REGIONAL REVIEW NOTIFICATION

ARC REVIEW CODE: R1902111

Name of Proposal: Atlanta Dairies (DRI 2897)

ATLANTA DAIRIES DRI #2897
City of Atlanta
Natural Resources Group Review Comments
January 29, 2019

TITLE
DRI SITE PLAN

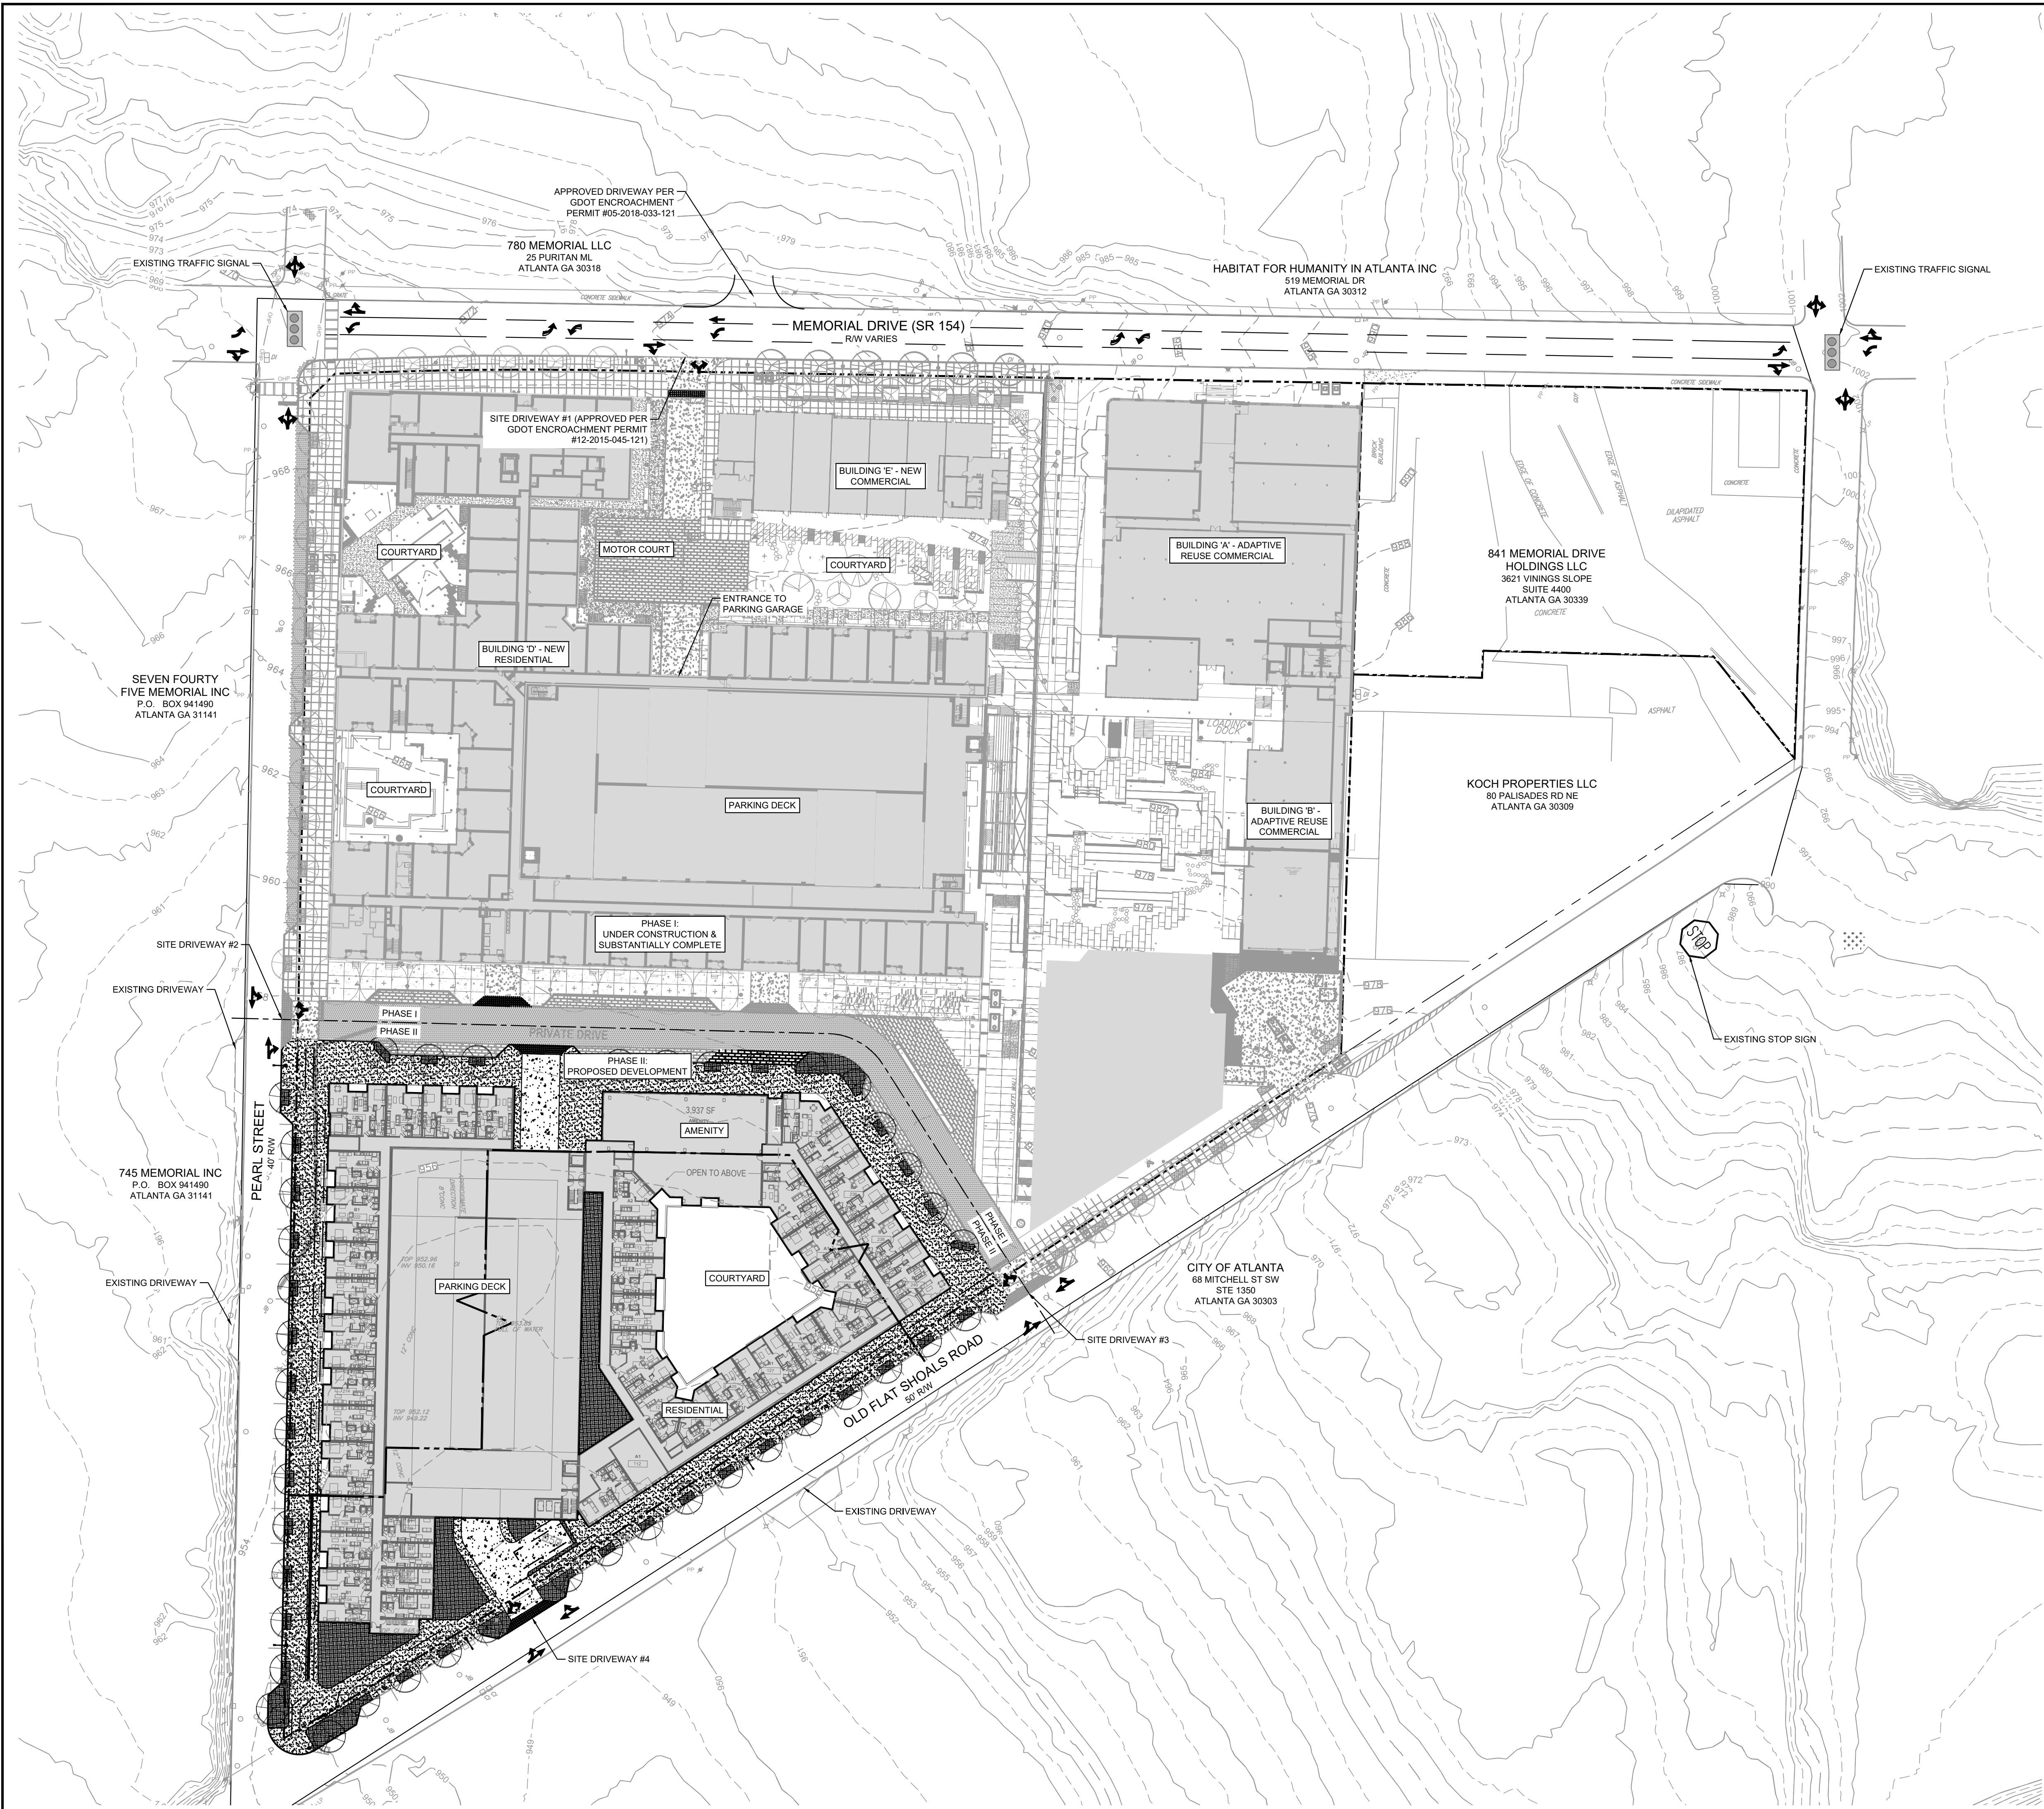
The development proposes four unsignalized full movement access points for the development: One on Memorial Drive one on Pearl Street and Two on Old Flat Shoals Road. Memorial Drive (SR 154) is a regional thoroughfare.

The development site will be access by SR 154/Memorial Drive which is identified as a Regional Truck Route however, Truck movement is limited to those servicing the area and not open to pass through truck traffic.

Adjacent parcels may be accessed by local roadways and driveways.

The development proposes pedestrian facilities internal to the site. Existing facilities along adjacent roadways provide pedestrian connections to adjacent sites.

Connections to adjacent parcels are provided through Pedestrian facilities existing along adjacent roadways.
